Site Address: 20 Spring Grove, Gravesend, Kent DA12 1LL

Planning Application ref: 20231280

Appeal ref: APP/K2230/D/24/3342187

SUBJECT: CONDITION DISCHARGE STATEMENT
FOR THE APPROVED APPEAL DECISION NOTICE – Resubmission

Proposed Materials

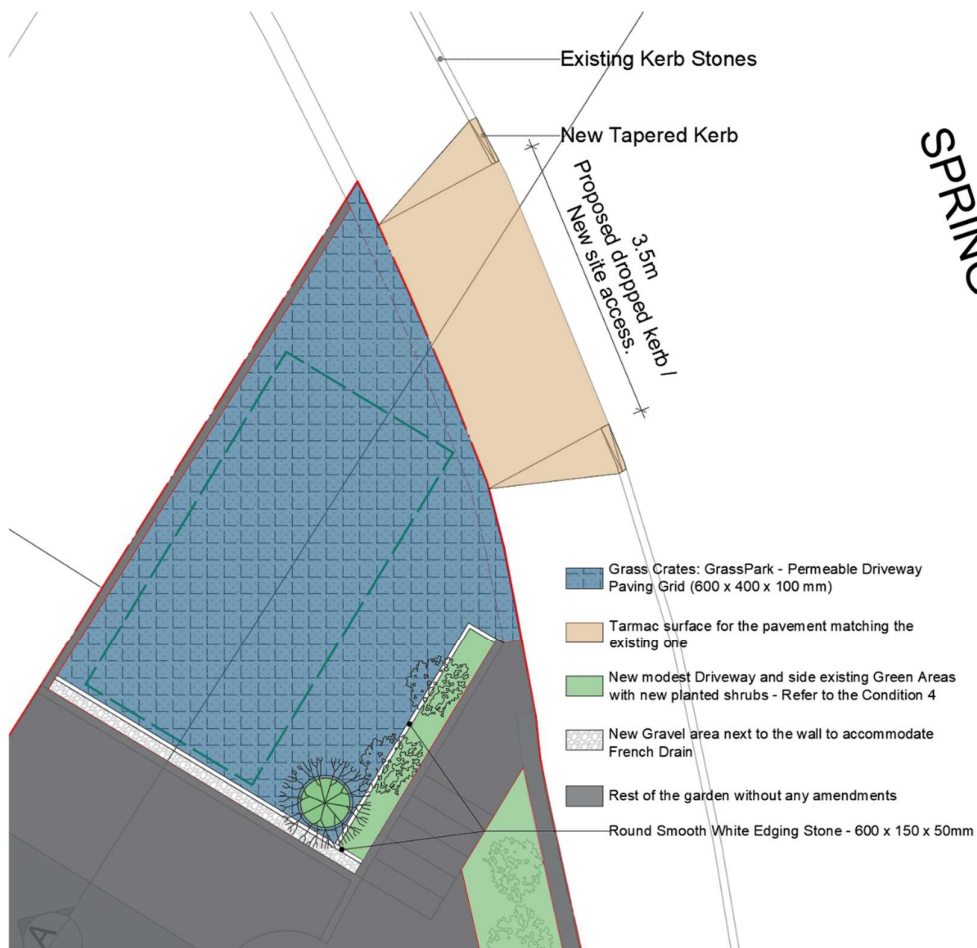
- 1. The submitted details of the block paving do not resemble grasscrete or similar, which was suggested by the Planning Inspector to compensate for the loss of the grassed area and low-level shrubs, and therefore conflicts with the objectives of Policies CS12 and CS19 of the Gravesham Local Plan Core Strategy 2014 and section 12 of the National Planning Policy Framework (NPPF), 2023.*
- 2. No detailed information regarding proposed planting has been submitted with the application to discharge condition 4 of APP/K2230/D/24/3342187*

- **Material Type:** Grass Crate - GrassPark - Permeable Driveway Paving Grid Size (600 x 400 x 100 mm) and Round Smooth White Edging Stone (600 x 150 x 50mm) around the new small green area and gravel area on the driveway.
- **Colour/Finish:** Concrete Blocks with grass between them, and white edging stone

Precedent photo of the material planned to be used in the parking area

Precedant photo of the Edging Stone

Visibility Splays

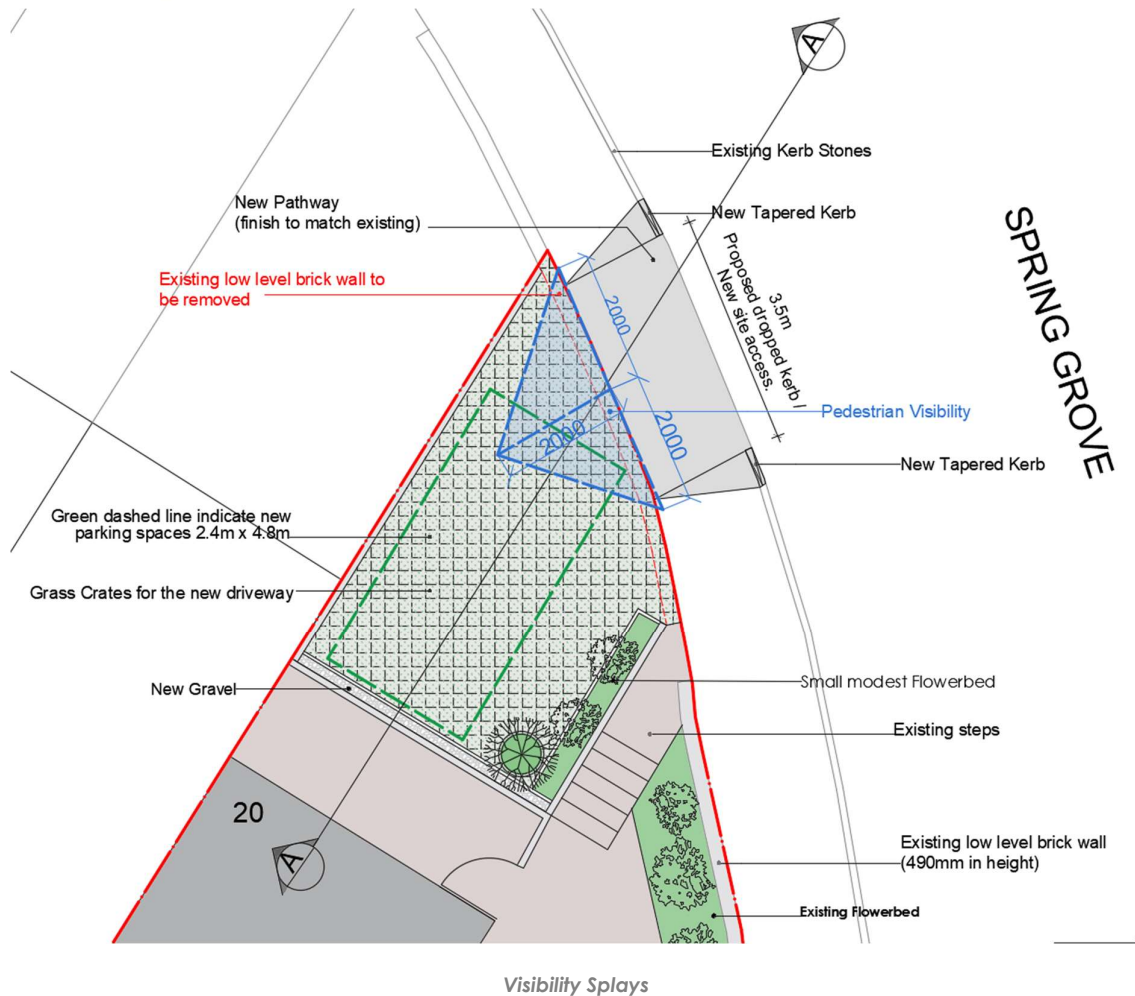
- 6) *Before the access hereby permitted is first brought into use 2.0m by 2.0m pedestrian visibility splays shall be provided at the back edge of the footway on either side of the vehicular access and thereafter no boundary wall, fence or other means of enclosure or obstruction exceeding 600mm in height shall be erected or placed within the visibility splays.*

1. **Visibility Splays:** We provide a 2m x 2m pedestrian inter-visibility splay to the back edge of the footway to ensure that drivers have a clear sight of pedestrians when emerging onto the highway. These splays are free of any obstructions, and boundary walls or fencing are no more than 0.6m high.
2. **Height Restrictions:** No boundary wall, fence, or other means of enclosure or obstruction exceeding 600mm in height will be erected or placed within the visibility splays. This will ensure that the visibility splays remain unobstructed at all times.
3. **Maintenance:** The visibility splays will be maintained to ensure they remain clear of any obstructions exceeding 600mm in height, in accordance with the approved details.

Proposed boundary wall elevation

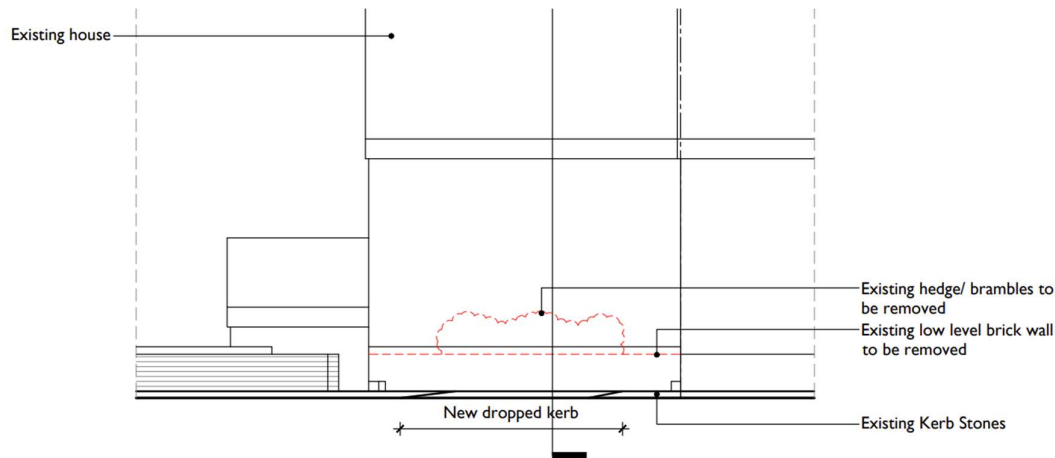
7) No gates shall be installed across the vehicular access hereby permitted at any time.

In compliance with Condition 7 of the planning permission, we confirm that no gates will be installed across the vehicular access at any time. The client has no plans to install any type of gate for the designated parking space in the garden.
